UNITED STATES PATENT AND TRADEMARK OFFICE

APPLICATION NO.	FILING DATE	FIRST NAMED INVENTOR	ATTORNEY DOCKET NO.	CONFIRMATION NO.
10/537,124	06/02/2005	Sachin Aggarwal	492322028400	8384

Office Action Summary

DETAILED ACTION

FIG. 2B

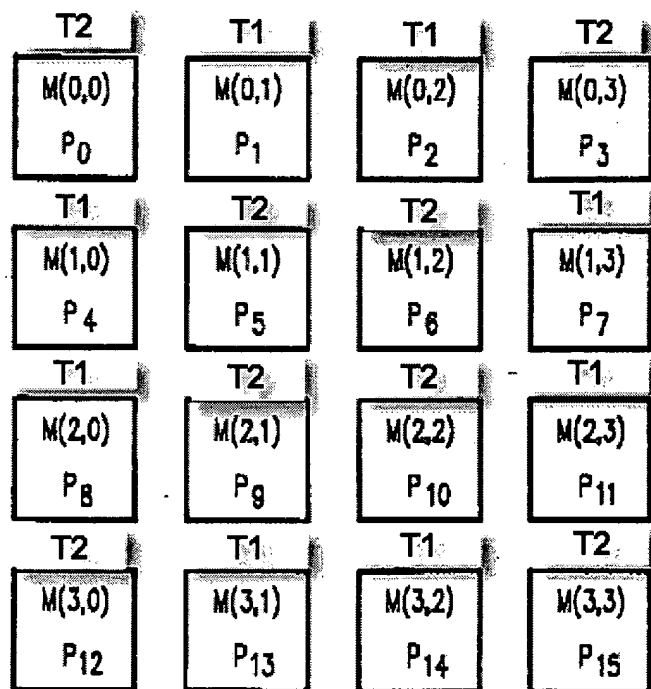
As shown Fig. 2B, Ho discloses mesh configuration of (i.e., 4 X 4 matrix circuit layout) circuit switch layout for concurrently performing a transportation of all data blocks on all processors including sub-mesh (i.e., sub-transistors). T1 = first transistor T2 second transistor and [M(0,0), M(1,1), M(2,2), M(3,3), M(0,3), M(1,2), M(2,1), M(0,3)]

are equivalent to the sub-transistors of the second transistor (T2), and [M(0,1), M(0,2), M(1,0), M(1,3), M(2,0), M(2,3), M(3,1), M(2,2)] are equivalent to the sub-transistors of the first transistor (T1).

Re claim 8, as shown in Fig. 2B, Ho discloses a circuit layout configuration for matching two transistors, comprising: a first transistor (T1) comprising eight first sub-transistors (i.e., [M(0,1), M(0,2), M(1,0), M(1,3), M(2,0), M(2,3), M(3,1), M(2,2)]); and a second transistor (T2) comprising eight second sub-transistors (i.e., [M(0,0), M(1,1), M(2,2), M(3,3), M(0,3), M(1,2), M(2,1), M(0,3)]), wherein the eight first sub-transistors (i.e., [M(0,1), M(0,2), M(1,0), M(1,3), M(2,0), M(2,3), M(3,1), M(2,2)]) and the eight second sub-transistors i.e., [M(0,0), M(1,1), M(2,2), M(3,3), M(0,3), M(1,2), M(2,1), M(0,3)]) are arranged in a four by four matrix, the eight second sub-transistors (i.e., [M(0,0), M(1,1), M(2,2), M(3,3), M(0,3), M(1,2), M(2,1), M(0,3)]) occupy eight diagonal positions of the four by four matrix, and the eight first sub-transistors (i.e., [M(0,1), M(0,2), M(1,0), M(1,3), M(2,0), M(2,3), M(3,1), M(2,2)]) occupy positions of the four by four matrix that are not the diagonal positions (see Figs. 2A – 5 and related text Col. 2, line 1 through Col. 11, line 39).
